These amendments revise the Technical Specifications to change requirements for administrative controls. The other changes you requested for Units 2 and 3 in your November 2, 1977 letters will be handled by separate licensing actions.

INDIAN POINT NUCLEAR GENERATING UNIT NO. 1

AMENDMENT TO PROVISIONAL OPERATING LICENSE

Amendment No. 18
License No. DPR-5

Figure 6.2-1 Facility Management and Technical Support Organization

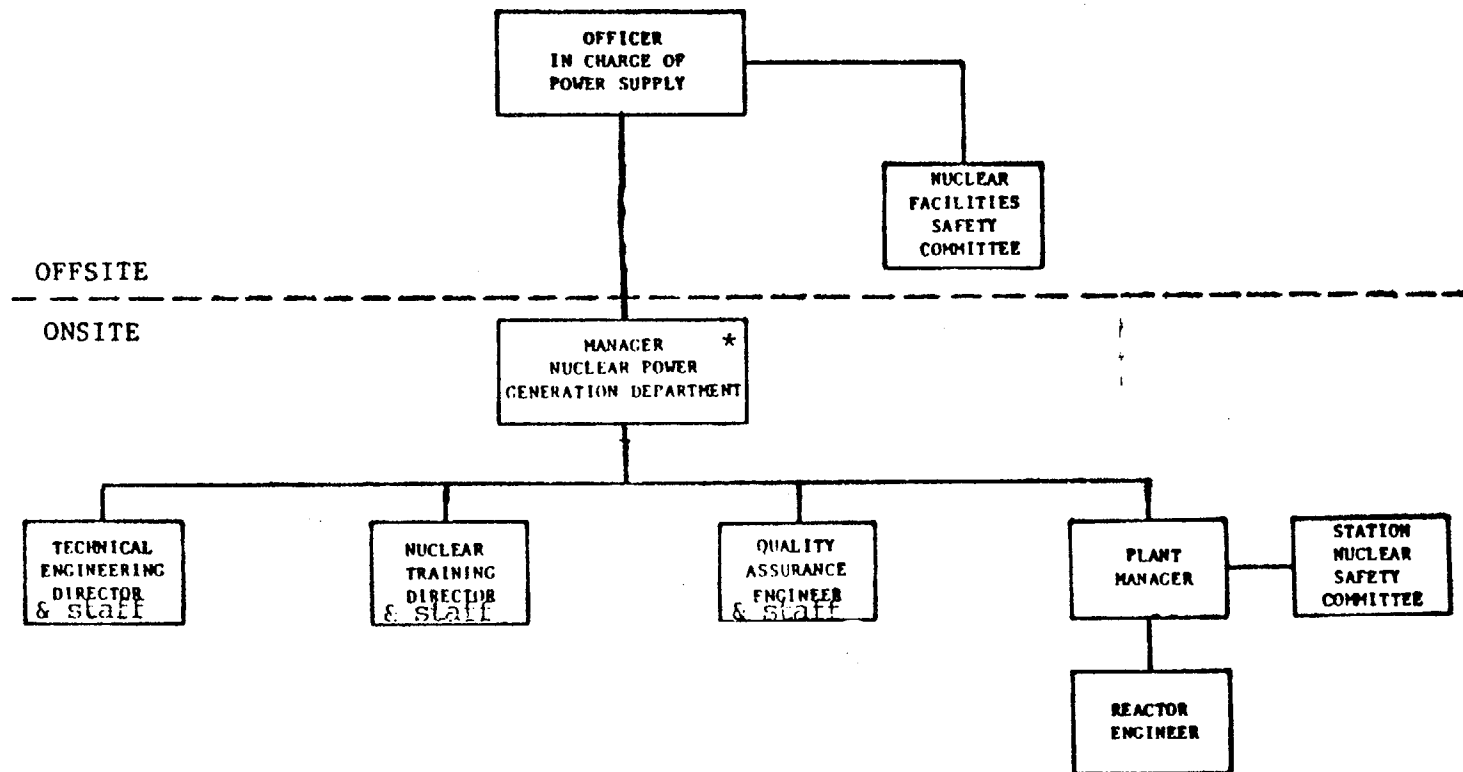
1. Change Technical Specifications to clarify Nuclear Facilities Safety Committee responsibilities;
2. Change organizational chart to reflect current organizational responsibilities to show that the Manager-Nuclear Power Generation Department would report directly to the Officer In Charge of Power Supply; and
3. For Units 2 and 3 add the Refueling Engineer as a member of the Station Nuclear Safety Committee.
